Safety Evaluation Report
for the
Application for Contents Amendment for Shipping
Isentropic Compression Experiment (ICE) Apparatus
in 9977 Packaging
Revision 2
February 20, 2009

Docket Number 09-05-9977

March 2009

Figure 4-3 ICE Configuration in the 9977 (6CV)

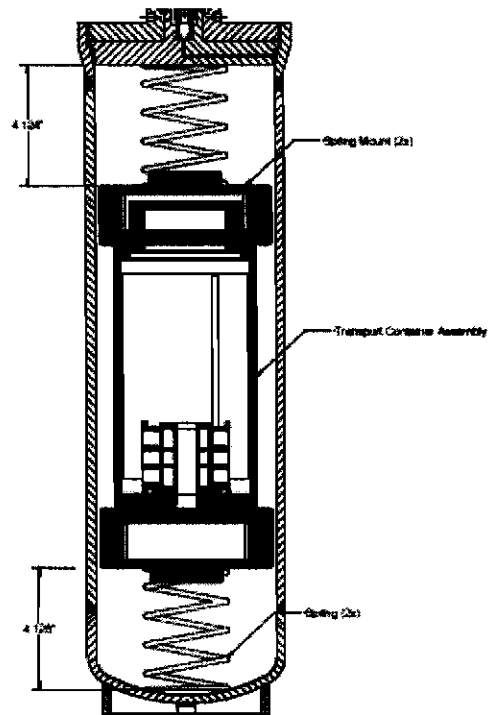
The ICE apparatus consists of a stainless steel assembly containing about 8 grams of ^{239}Pu or its dose equivalent as noted in Table 1, *Comparison of 9977 Content C.1 and the ICE Radioactive Contents*, of the Submittal. The ICE target is mounted on the transport container assembly base. A Viton[®] O-ring seals the transport container base to the transport container body. Another Viton[®] O-ring seals the transport container handle to the transport container body. The ICE apparatus weighs less than 30 pounds^[5] and has less than 0.6 watts decay heat rate. For the Model 9977 Package, the maximum payload weight is 100 pounds and the maximum decay heat rate is 19 watts.^[2] Thus, the maximum payload weight and the maximum decay heat rate for the Model 9977 Package easily bound those for the ICE apparatus. Figure 4-3, *ICE Configuration in the 9977 (6CV)*, and Figure 4-4, *Required Foam Within Coil Springs (Top Shown, Bottom Similar)*, are reproduced from the document, *9977 Containment Vessel Dynamic Response with ICE Payloads*.^[5] The Figures show the packaging system, consisting of two spring mounts (6061-T6 aluminum), two springs formed from American Society for Testing and Materials (ASTM) A 288 QQW-470 steel music wire, and two square blocks of foam (Last-A-Foam[®] TF-5070-10 or equivalent) retained within the springs. The springs and blocks alone do not provide adequate damping for vibrations, arising from transportation, and the addition of foam energy-absorbing materials is necessary.

- Drawings for the ICE Container Assembly^[4]:
R83700, *LANL Transport Container Assembly*
1001-0269-0000, *Platform, Pu Anode, Inner*
1103-0355-0000, *Panel, ICE, Floor*
1103-0388-0000, *Panel, 17mm Spacer, ICE*
1103-0389-0000, *Plug, Panel, 17mm Spacer*
1350-2333-0000, *Fitting, 1/8 to 1/8, Custom*
1350-2357-0000, *90° Adaptor Fitting*
1350-2495-0000, *Probe Nut*
1350-2496-0000, *Mount, Probe Body, 3-Point*
R83710, *Transport Container Handle*
R83711, *Transport Container Anode Mount*
R83712, *Transport Cannister Body*
R83722, *Transport Container Strain Relief*
2-045, *Viton O-Ring*
502-440-716-AAA2, *Socket Head Cap Screw, alloy steel*
502-1420-1-AAA2, *Socket Head Cap Screw, alloy steel, and*
- Figure 4-1, *Springs Supporting ICE Transport Container Assembly*^[5]
- Figure 4-2, *Spring Mount Design*^[5]

Figure 4-4 Required Foam Within Coil Springs (Top Shown, Bottom Similar)

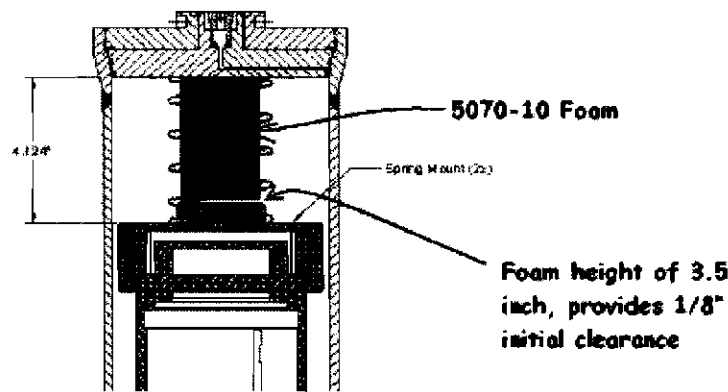
The ICE assembly requires a set of spring mounts, a set of springs, and a set of square blocks of foam, retained within the springs, in order to achieve adequate damping of vibrations during transportation in the 6CV for the Model 9977 Package.^[5] However, the ICE assembly has to be an approved content configuration per Section 7.1.1.2, *Contents/Payload Preparation*, of the Model 9977 Package SARP in order to be loaded into that Packaging, so, there are no changes to Chapter 7 of the Model 9977 SARP.
